CAF-R2 | installed-lid driver clearance

Native-derived section X=-32, positive-Y screw. Dimensions mm;10 points/mm (PDF3.528:1).

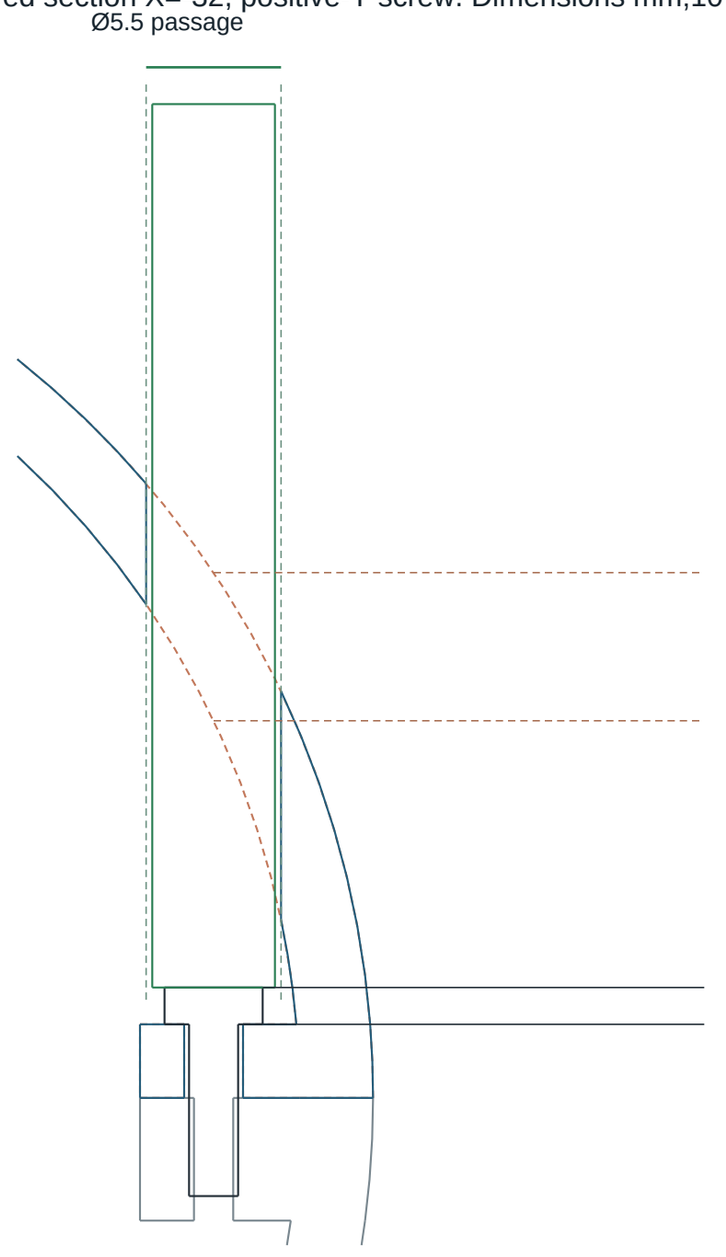
Four passages: X -110/-32; Y +/-32

Existing driver Ø5, Z4.5..40.5; cut Ø5.5, Z4.0..41.5

Nominal whole-tool gap0.25; cut starts0.5 below tip

Allocation: radius undersize0.10 + driver0.05 + axis0.05

Outer radius38.5: centreline exit Z21.4068

Inner radius35.5: centreline entry Z15.3704

Original centreline blockage6.0363; red dashed = frozen original

Original four solid intersections127.758..127.838 mm³; repaired0

Head top/tool tip Z4.5: intentional face touch, no volume

Bearing seat Z3: Ø4 head / Ø2.4 hole; radial land0.8

All four8.04248 mm² bearing areas preserved; bosses remain connected

Through-open ports; caps/sealing/IP/strength decisions remain UNMET

Only UpperShellRetention changes. No other parts, screw positions, boards, envelope or rotary geometry change.
